CNWRA *A center of excellence in earth sciences and engineering*

February 1, 2002

Subject: The DOE Position on Drift Collapse

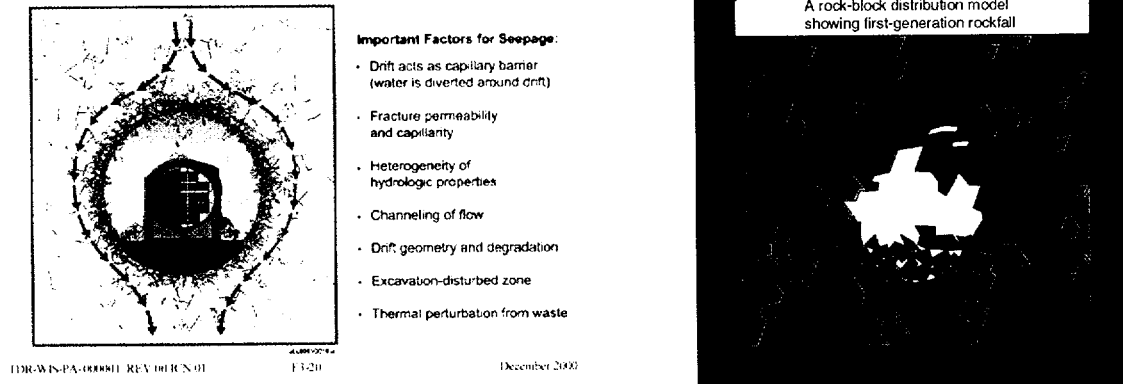
In our opinion, it is unlikely that an acceptable technical basis can be developed to support the current DOE position on drift collapse, which is that the emplacement drifts will not experience significant collapse through the 10,000-year period of regulatory concern. An acceptable case for drift collapse would require information about the potential effects of drift collapse on repository performance. One implication of the DOE position on drift collapse is shown in Figure 1, which is a schematic illustration of the DOE abstraction of moisture flow through the repository horizon. The moisture flux that intersects the drift perimeter (i.e., the deep percolation flux, Q_p) is split into two parts: a part flows around the drift because of the capillarity of the drift opening and the remaining part (q_s) enters the drift opening. The quantities Q_p and q_s are evaluated based on an abstraction of results from process-model calculations that assume a fixed geometry for the emplacement drifts through the entire simulation period. The ratio q_s/Q_p used in DOE's performance assessment (CRWMS M&O, 2000a, Tables 8 and 11) varies with the deep percolation flux, but is generally smaller than 0.05 for values of Q_p of 15 mm/yr or smaller. That is, only 5% or less of the available deep percolation flux may seep into the emplacement drifts in the DOE performance assessment model. The other 95% or more is diverted around the drift because of the capillarity of the drift opening. An examination of Figure 1(b) indicates a serious cause for concern regarding how much of the initial capillary barrier associated with the drift opening can be assumed to be retained following the onset of drift collapse. As Figure 1(b) shows, the collapse of drifts would create several enlarged fracture spaces that would intercept capillary-held moisture and redirect it into the drift. As a result, the applicable values of the ratio q_s/Q_p may be significantly larger than the values used in DOE's performance assessment.

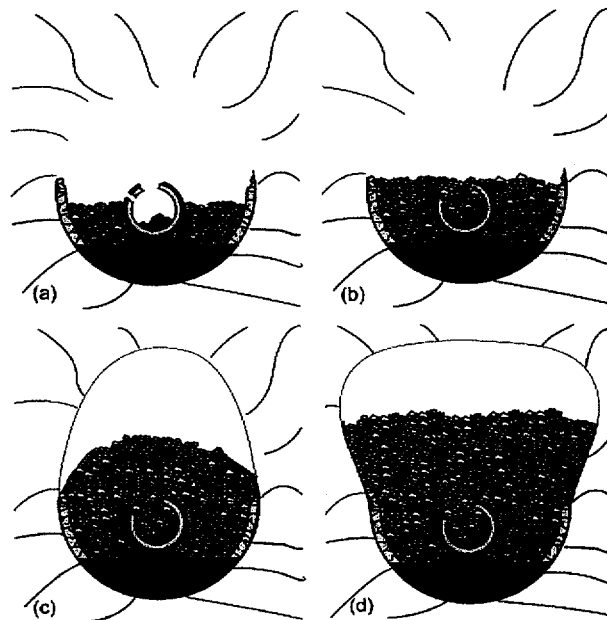
Both the type and degree of drift collapse are likely to vary with time and with rock-mass characteristics as illustrated schematically in Figure 2. For example, the collapsed shapes in Figure 2(b) and (c) may result if collapse is controlled by near-vertical fractures whereas the shape in (d) would result if collapse is controlled by horizontal fractures. The extent of the failure zone and the volume of broken rock that would accumulate in the opening depend on several rock-mass characteristics, such as fracture frequency and orientation, and rock strength. The variability of collapsed-drift characteristics illustrated in Figure 2 indicates that the calculated significance of drift collapse to repository performance would be affected by the assumptions made regarding the timing and rate of drift collapse and the extent of the associated rock failure.
